RESPONSE TO S92 REQUEST CRC173284 - CRC173289

As requested in your correspondence (dated 9 December 2016) this letter provides additional information related to the resource consent applications for the proposed BCIL Akarana Storage Pond. This letter answers the questions in the same order as they are expressed in your S92 request.

Figure 1 : K36/0051 Depth to Groundwater

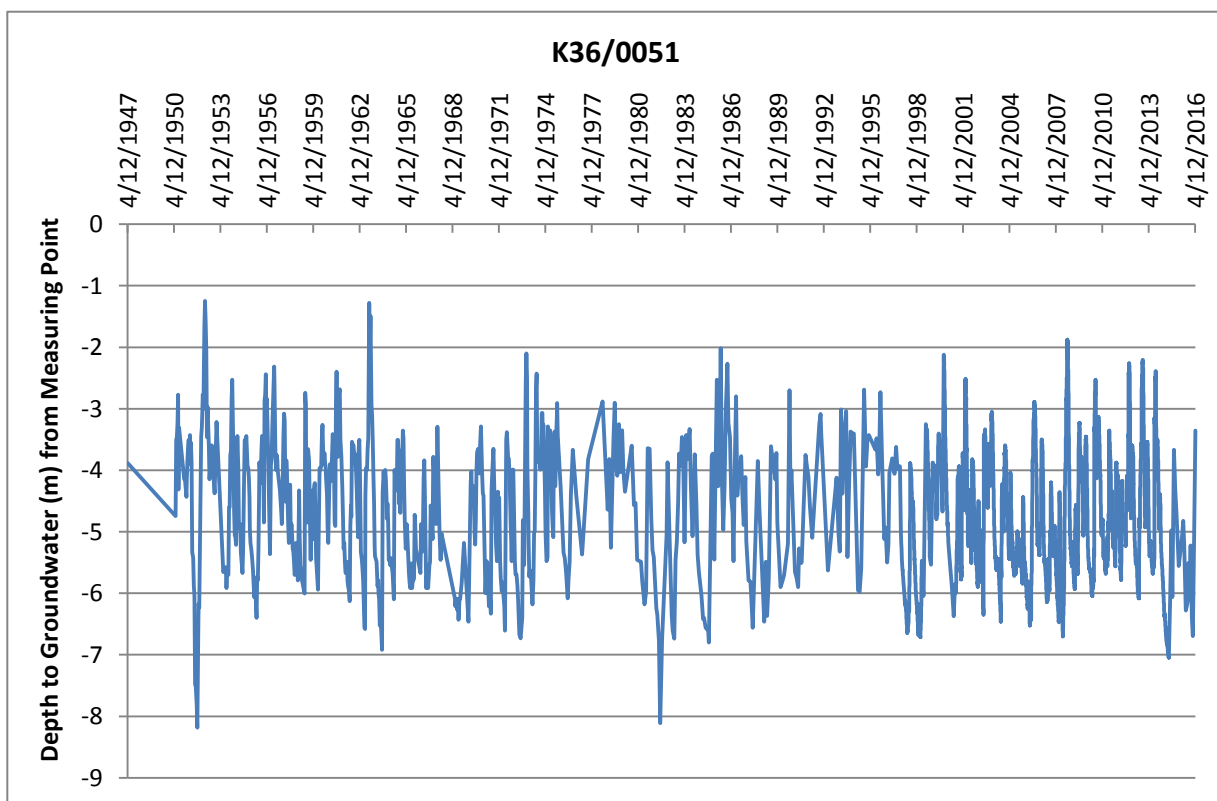
Question 3 a. The groundwater level information provided with the application is sourced from water level readings dated in the 1950's and 1960's with a few spot measurements in more recent years. There is therefore a lack of certainty of what the current range of groundwater levels at the proposed site as they will depend on current Rangitata Diversion Race (RDR) losses (which may be quite different than in the past) and on longer term groundwater level trends.

Please provide further information regarding current groundwater level conditions at the proposed site.

Response to question 3 a: The efficiency of the RDR race over time (including seepage losses from the channel) has been described in the evidence from Young (2003) for the Rangitata River Water Conservation hearing. He indicates that the efficiency of the race pre-1996 was between 90 and 95 % and comments that work from a natural resources engineering student in 1996 show that in 1996 these losses had reduced to between 94 and 98 % with RDR adopting a loss rate of 1.37 m³/s for the full length of the

RDR (a loss of around 4.4 %). In 2000/2001 the available hydrometric data indicated that the efficiency averaged 96.5 % (a loss rate of 3.5 %). Based on this information it appears that no significant change in RDR seepage losses has occurred or perhaps a slight decrease in seepage over time.

An ECan report titled Land-surface recharge and groundwater dynamics: Rakaia-Ashburton Plains (2010) (Report No. R09/55) provides time series plots of groundwater levels for the plains area in the vicinity of the proposed storage pond. Although the plots provided do not include the period in the 1950's – 1960's (the plots start in 1973/1974) the report indicates that groundwater levels in the area are either stable or show a decreasing trend. A search of the ECan GIS database indicates that the closest bores with available groundwater level data in the 1950's and 1960's and up to year 2016 are bores K36/0051 and K37/0215. Bore K36/0051 is located approximately 17 kilometres south-west of the site. A plot of the water level data from this bore is shown in Figure 1 below. This bore shows that groundwater levels have generally been stable from 1950 to present. K37/0215 is located approximately 28.5 kilometres south of the site. A plot showing water level data from this bore is provided as Figure 2, which shows a decreasing trend in groundwater levels approximately since the year 2000.

Considering that seepage from the RDR has not changed or slightly reduced since the 1950's/1960's and that groundwater levels in the general either show a stable or decreasing trend over time it is likely that current groundwater levels at the site are similar or lower than those measured in the 1950's and 1960's.
